FREDERICK COUNTY PLANNING COMMISSION

TITLE: **Westview South Lot 107**

FILE NUMBER: **SP 12-11, AP 15099, APFO 15100, FRO 15101**

REQUEST: **Site Development Plan Approval**
The Applicant is requesting site plan approval for 20,750 square foot shopping center, on a 2.66-acre site

Graphic #1

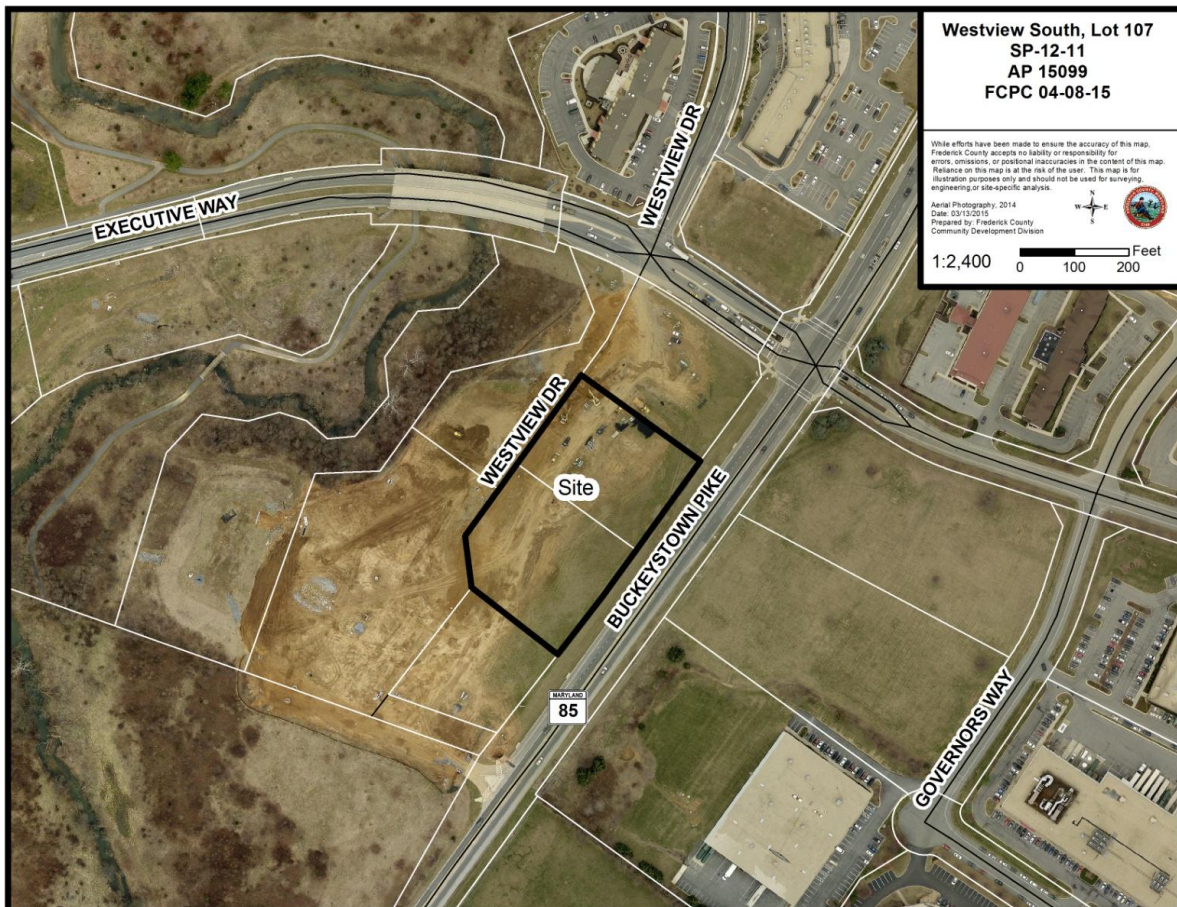
The Applicant is requesting site development plan approval for 20,750 square foot shopping center, on a 2.66-acre site. The proposed use is being reviewed as an "Shopping Center" land use under the heading of *Commercial Uses-Retail* per §1-19-5.310 Use Table in the Zoning Ordinance and is a principal permitted use in the General Commercial (GC) Zoning District subject to site development plan approval.

1. Parking setback modification from required 25 ft setback along MD 85 to 12.5 ft.
2. Light spillage modification
3. Light pole height modification from a maximum 18 ft to 22 ft.
4. Parking modification to provide 24 spaces more than the 114 minimum required spaces
